## NATIONAL FIRE EQUIPMENT SYSTEM CACHE MEMORANDUM NO. 08-2

To: NFES: National Incident Support Caches  
From: Paul Naman, NFES Representative - NIFC  
Subject: Helicopter Lead Line Retrofit

## Lead line Retrofit

Figure 1 – Lead line hook and cargo net links incompatibility.

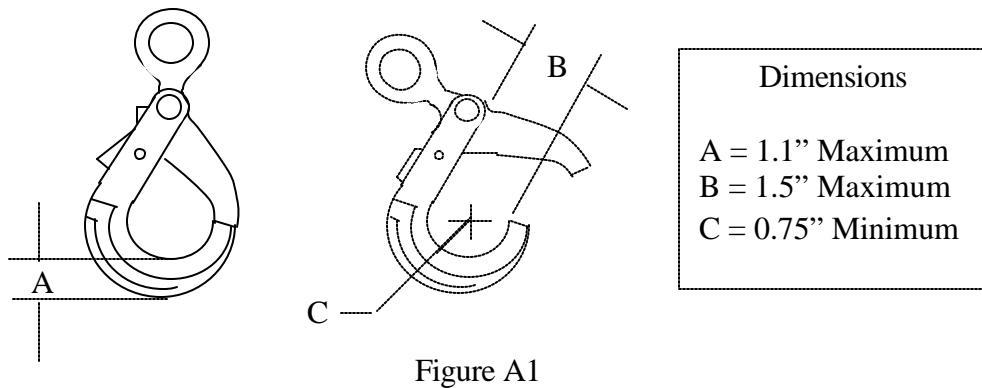
The Department of the Interior Aviation Management Safety Alert No. 05-02 identified a compatibility issue with certain helicopter lead lines and the standard 3,000 lb. cargo net. The compatibility issue is the inability of the spring gate on the lead line hook (J-hook) to close when the two links of the cargo net are inserted into the hook. See Figure 1.

The two rings of most cargo nets will not fit on the new smaller lead line J-hooks because the spring loaded keeper gate is too long to allow the two rings to be attached to the hook (see Figure 1). If the rings are forced onto the hook, the keeper gate can be bent or possibly broken, creating an unsafe condition by allowing one or both rings to accidentally slide off the hook during load operations.

1. Look for “China” on the side of the hook. See Figure 1. Note: Not all “China” hooks are problematic.
2. Insert two 5/8-inch links into the hook through the safety gate. See Figure 1.
3. Observe whether the gate closes over the links. See Figure 1.

If the safety gate does not close, closes by manipulating the links, or barely passes over the links, the lead line is a candidate for retrofit. Only if the safety gate easily passes over the links should it be placed back into service. Hooks where the gate barely passes over the links are identified as retrofit candidates because the links used in the examination may be on the small side of the allowed diameter tolerance for the part. Links, like the hooks, are forged parts. The manufacturing tolerance for forged commercial rigging equipment results in a fairly wide variation in diameters.

The most practical solution is the retrofit of the affected cargo lead lines. The retrofit involves the removal of the incompatible hook and replacing it with an acceptable hook. This results in a lead line that is shorter than the standard 12 feet. Consultation with field experts indicates that a shorter lead line is not an operational concern. There is no need to separately track or identify shortened/retrofitted lead lines.

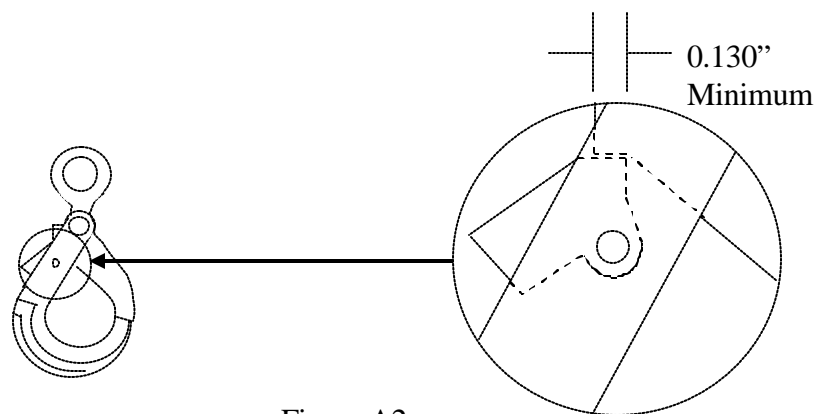
1. The contractor shall remove the existing hook and replace it with a hook that meets the following:
  - a. The hook shall have a minimum ultimate load of 11,250 lbs.
  - b. The hook shall have the dimensions shown in figure A1.

- c. A gate release shall be incorporated in the hook and have a spring return to lock the gate closed. The release lock and hook gate shall have a minimum engagement of 0.130 inches, as shown in figure A2, Gate Lock Engagement. (Note: The dashed lines in figure A2 are hidden lines.)

Figure A4, Tag Orientation in swage

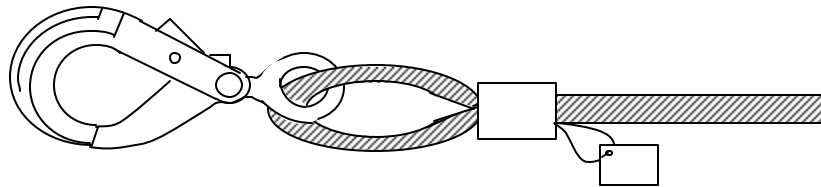
3. The contractor shall mark each retrofit lead line item with a tag showing the information in Figure A3. (Note: The date and company shown below in the tag information is a sample. The actual date of manufacture and proof testing shall be used.) The text size shall be a minimum 0.12 inches. The text shall be legibly and permanently stamped, embossed, cut, or etched on to metal tag. The tag shall be either stainless steel or brass. The tag shall be attached to the lead line at the hook end using a galvanized steel wire rope. The hole in the tag shall be greater than 1 and ½ hole diameters away from any edge of the tag. The securing wire rope for the tag shall be 1/16 inch galvanize steel. This wire rope shall be included in the swaging which attaches the hook. The loop formed shall be between 1 and 1-½ inches in diameter and oriented in the swage in the direction shown in figure A4.

Figure A6, Slip Indicator Paint

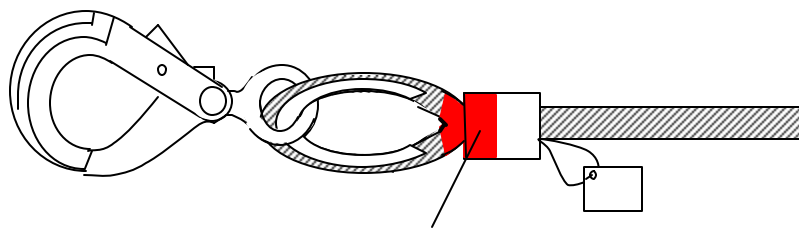
- The new hook shall be terminated in an eye using a thimble and a copper or zinc coated copper swage sleeve/collar. Aluminum swages/collars shall not be used. The wire rope shall be stripped of the plastic coating before swaging. The swaged area shall not incorporate any part of the plastic coating. All swages shall be painted for slip indication (see figure A6). The paint color shall be red. The paint shall be applied by spraying and applied in the area shown in figure 5 all around (circumferentially) the lead line. Swages shall not be covered. No splices shall be allowed in the cable. The terminated hook end of the cable shall be fully contained within their swages, i.e. the end of the wire rope shall be flush with the swage collar or extend outside the collar no more than 0.125 inches. In no case shall the end of the cable be contained within the collar, i.e. recessed inside the collar after swaging.
